**Comments on PJM & ITRON
Load Forecasting Recommendations
*Draft***

Date: 12/6/2010

Figure 29: Weighted Economic Variable (Commonwealth Edison)

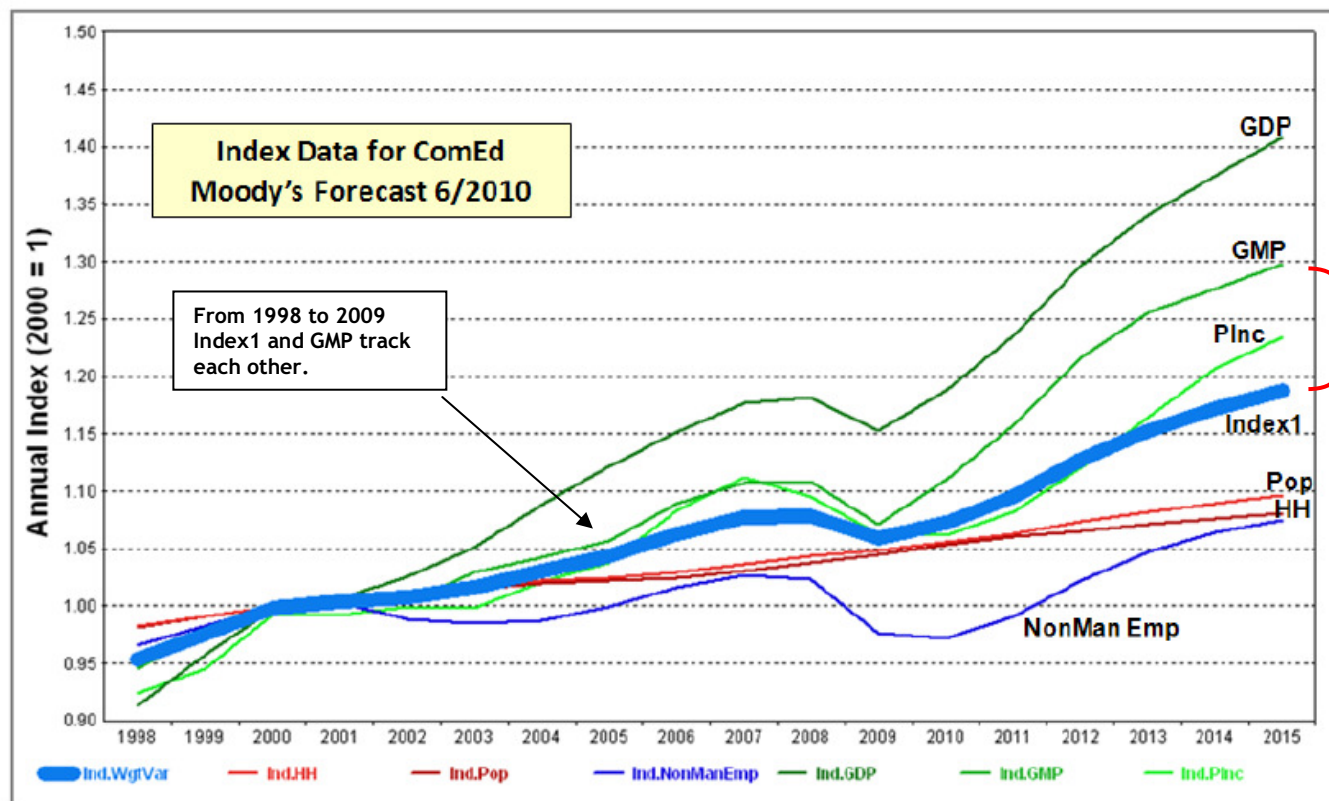
Index1 has a systematic downward bias because the higher weights are assigned slower growth variables

- GMP Model captures the large downward and upward year-on-year load changes in 2009 and 2010, respectively.
- Population and households have low and steady growth rate, so Index1 reduces load growth relative to GMP.
- The weights for population, household and non-manufacturing employment should be lower versus GMP & GDP.

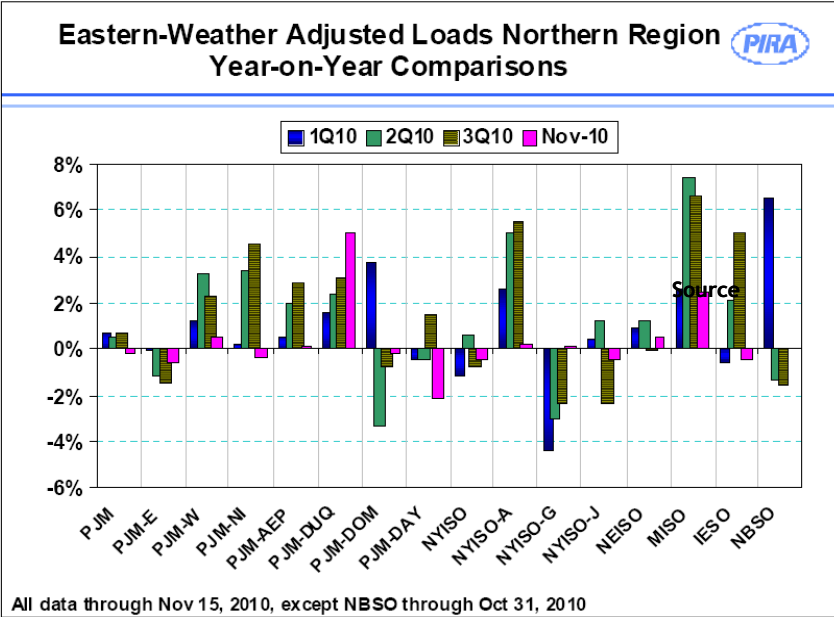
Index1 puts too much weight on slow growth variables such as Population and Households

Load changes are much more sensitive to GMP and GDP than to other variables.

- Based on PIRA estimates, the changes have been above 4% for Commonwealth Edison during Q3-2010.
- Weather-adjusted load changes are much larger than those predicted by Index1. (see chart top right)
- Load changes are much more sensitive to Gross Metropolitan Product and GDP than to other variables.
